SUBJECT: REQUEST FOR ADDITIONAL INFORMATION FOR THE REVIEW OF THE  
MODEL NO. HI-STAR ATB 1T PACKAGE

Request for Additional Information  
Holtec International  
Docket No. 71-9375  
Model No. HI-STAR ATB 1T Package

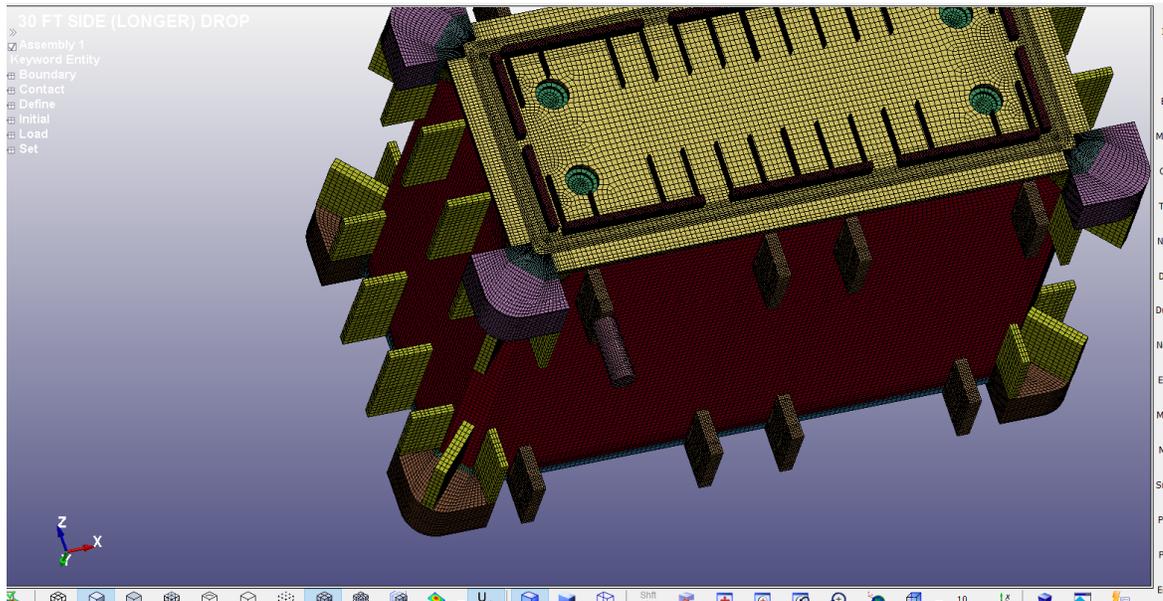
- 2-6 Justify the ratio of hourglass energy to internal energy observed for certain parts of the ATB-1T package during drop simulations in LS-DYNA.

As stated by the applicant, the ratio of hourglass energy to internal energy should be kept to a ratio of 10% or less, as hourglass energy indicates that a nonphysical part of internal energy is present in the model, which, in turn, implies that deformations and the overall physical behavior of the part may not be realistic simulated.

Several drop simulations, such as the 30 ft top end drop, exhibit ratios for certain parts which grossly exceed 10%; as an example, the top lid of the BTC (model part 29) observes a ratio of 130%, part 23 (intermediate dose blocker plate) in the model observes ratios of greater than 30%, and several others parts, not mentioned here, exceed 10% by smaller amounts.

According to calculation 5 of document HI-2177540R2, the BTC side walls and the top/bottom plates of the BTC have to avoid gross yielding and rupture, which is difficult to ascertain given the large amount of hourglass energy observed. The applicant shall verify and/or justify these large values or update the application and simulated drop sequences, as necessary.

Puncture Bar Centered over Sealing Surface at Side Impact Absorber (Side Drop Orientation Shown)

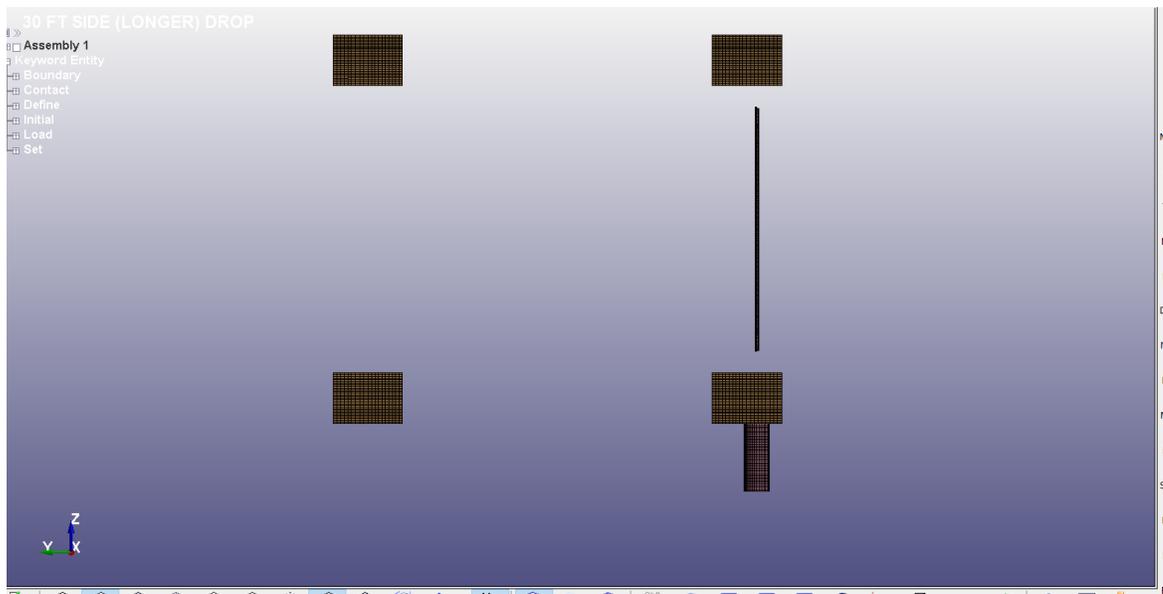
- 2-7 Describe the condition of the sealing surface of the package when subject to the 9 m side drop, followed by a 1 m puncture drop at the side impact absorber near the sealing

surface. Clarify and justify how containment requirements will be met given inelastic deformations are observed for the 9 m side drop.

The package's sealing surface (cladding) experiences inelastic deformations after the 9 m side drop next to the side aluminum impact absorbers (BOM 42 of the licensing drawings). It appears that additional damage could be experienced in this region as a result of the 1 m puncture drop (cumulative damage) in the area as shown:

Additional damage in this region could further hinder and jeopardize the package's ability to maintain containment regulatory requirements.

A justification that containment requirements, such as leak rates, will be met given inelastic deformations at the closure region after the 9 m side drop has not been provided (see also containment RAI 4-1). The applicant shall update the application and all associated calculations, as necessary.

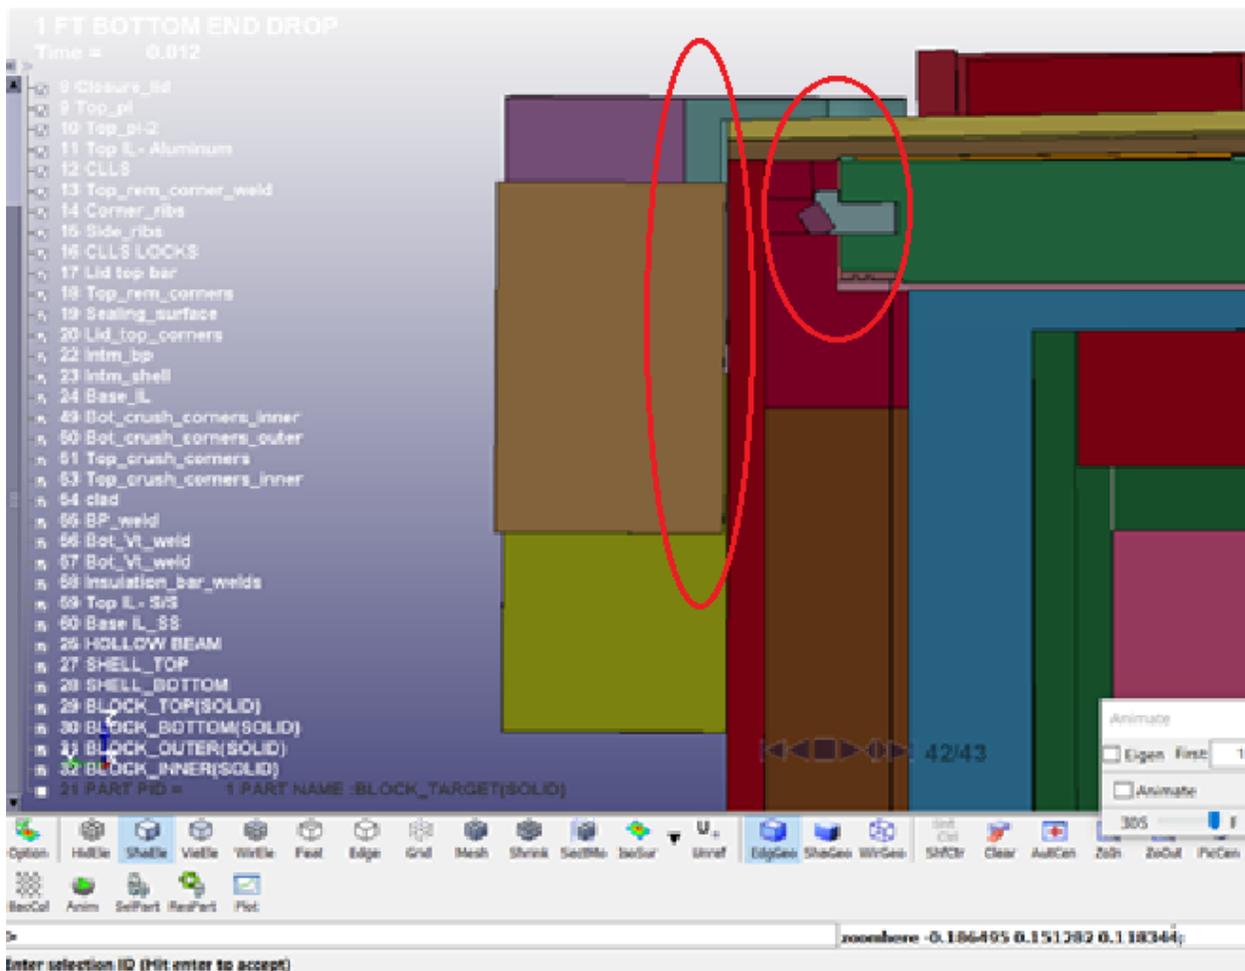
2-8 Clarify the location of the aluminum impact absorber plates on the licensing drawings and their attachment in drop simulations.

Licensing drawing 9786 (Sheet 7 of 7) depicts the relative arrangement between aluminum impact absorbers (BOM part 42). However, their location relative to the cask itself has not been provided. These plates are partially missing from the 1 ft bottom end drop, 1 ft top end drop, and 30 ft BOT CGOC + 1 m puncture drop simulations. In the case of the 1m drops, they also do not appear to be connected, as shown below. In addition, it appears that part 16 of the model, CLLS locks, rotates unnaturally through its neighboring parts.

Impact absorbers are intended to reduce the demands on the containment boundary. It is unclear how “loose” or “missing” impact absorbers will affect the package’s performance. The applicant shall update existing drop simulations and the application as necessary, including the licensing drawings.
